# Alameda Point Adaptive Reuse Street Sections

Proposed updates to the Master Infrastructure Plan and Main Street Specific Plan

# Proposed Changes to Lane Widths

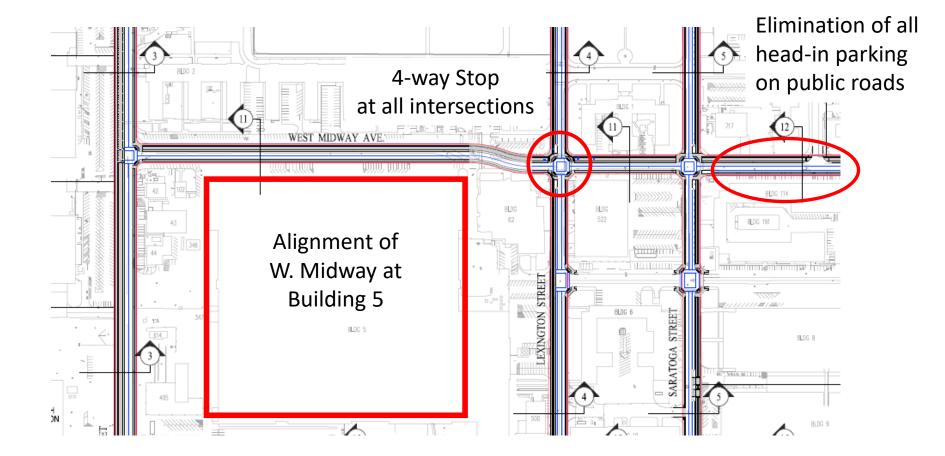
Island Arterial – 12ft next to curb, 11ft next to parking or bike lane

Local Street – 11ft next to curb, 10ft next to parking or bike lane

Fire Access requires 13ft lanes where zoning permits 30 foot tall structures adjacent to roadway

# Other Proposed Changes

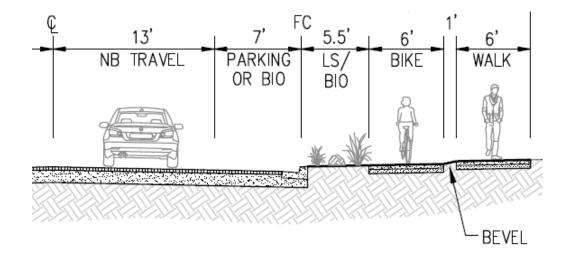
- Minimum 6 foot sidewalks throughout Alameda Point
- 1-Way Cycle Track adjacent to sidewalks

# W. Redline Ave

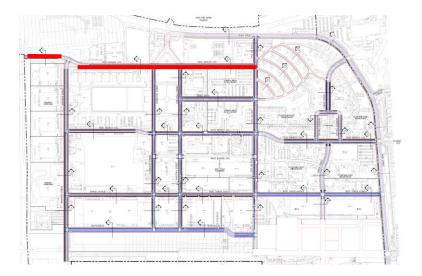
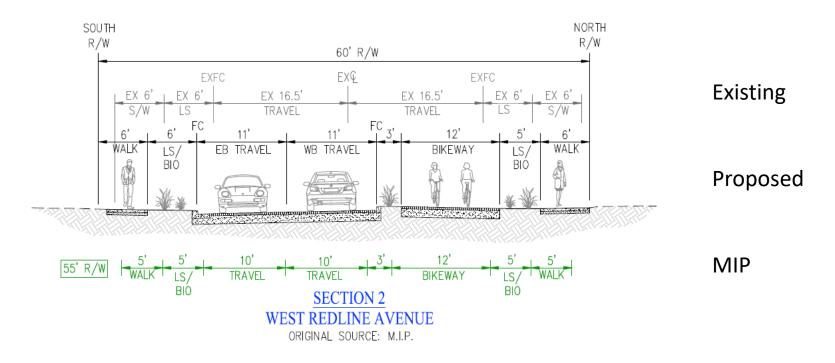
- Widen travel lanes to 11ft
- Widen sidewalk to 6ft

# Lexington Street

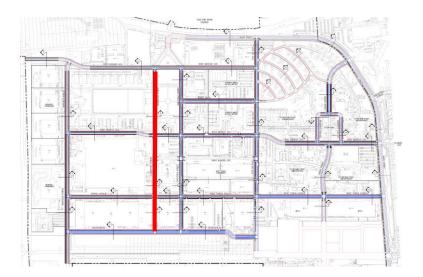
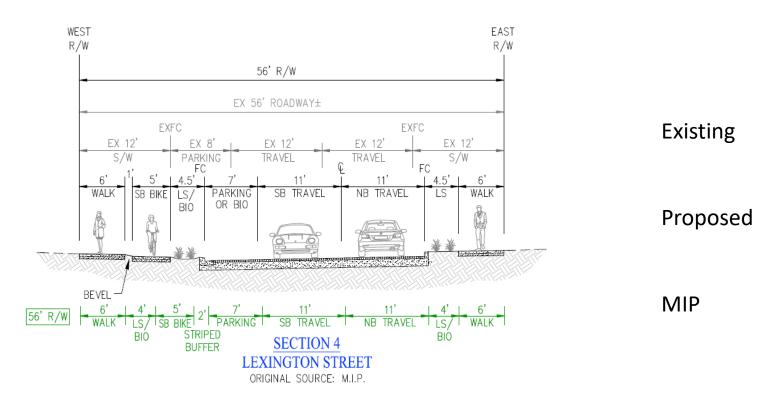
- Widen non-cycle track travel lane to 13ft, Sharrows?
- Move bike lane adjacent to walk
- Similar change to Saratoga Ave

# Pan Am Way

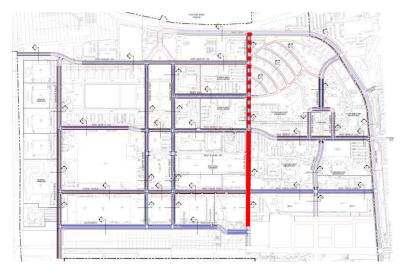
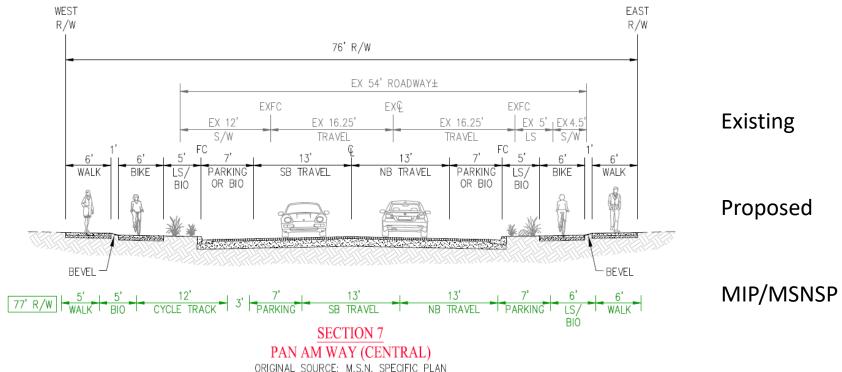
- 1-Way cycle tracks
- Similar to Orion St in Site A

# W. Midway Ave

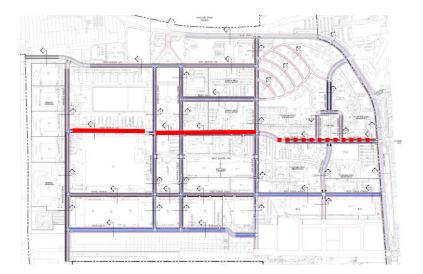
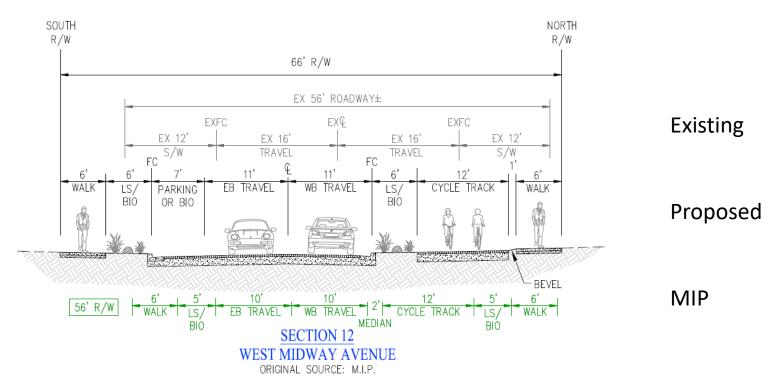
- Widen lanes to 11ft
- Add parking opposite of cycle track
- Shift roadway away from Bldg 5
- 13ft lanes within West Midway RFP

# W. Tower

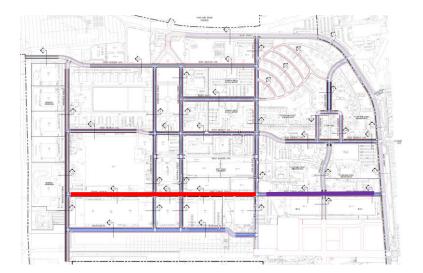
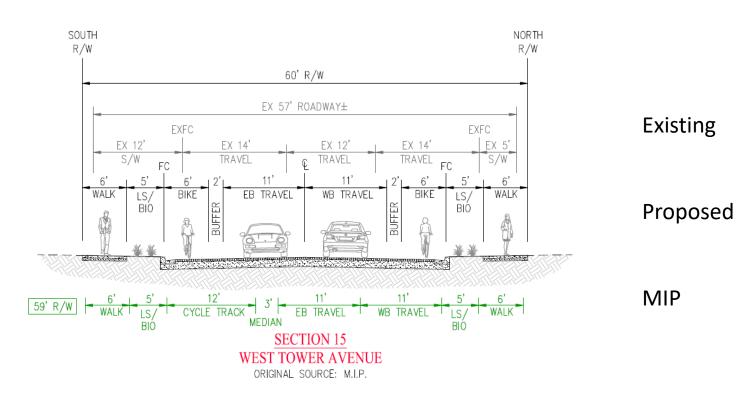
- Buffered Class 2 bike lanes for full length
- Shift Cycle Track to Seaplane
- Add buffer and widen bike lane east of Pan Am

# Seaplane

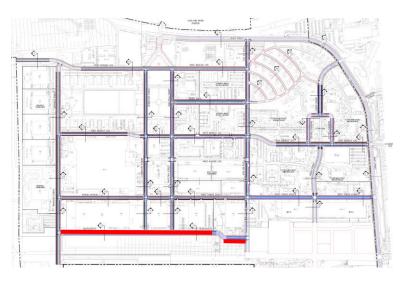
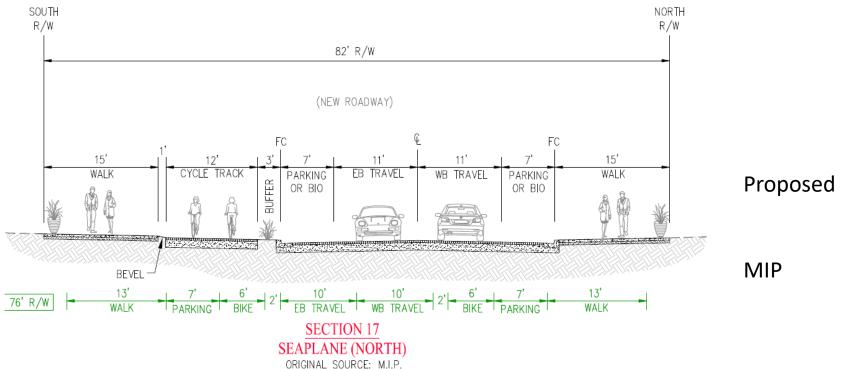
• Cycle track on lagoon side of roadway

# **Essex** Drive

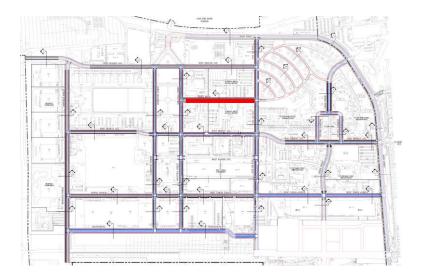
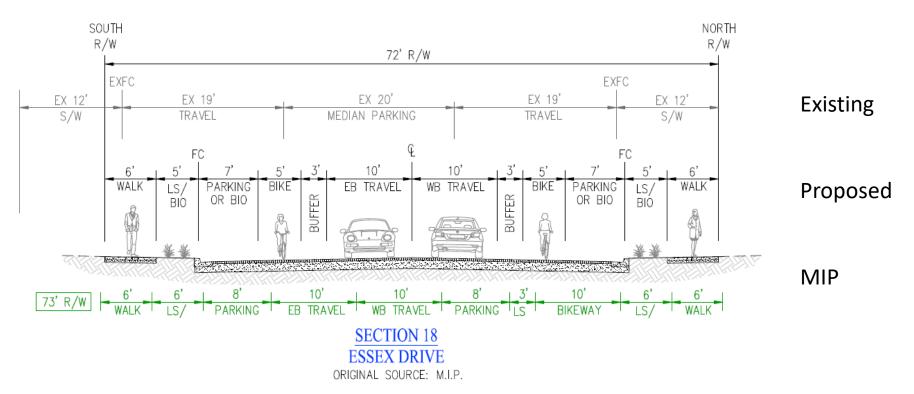
- Eliminate cycle track
- Add buffered bike lanes
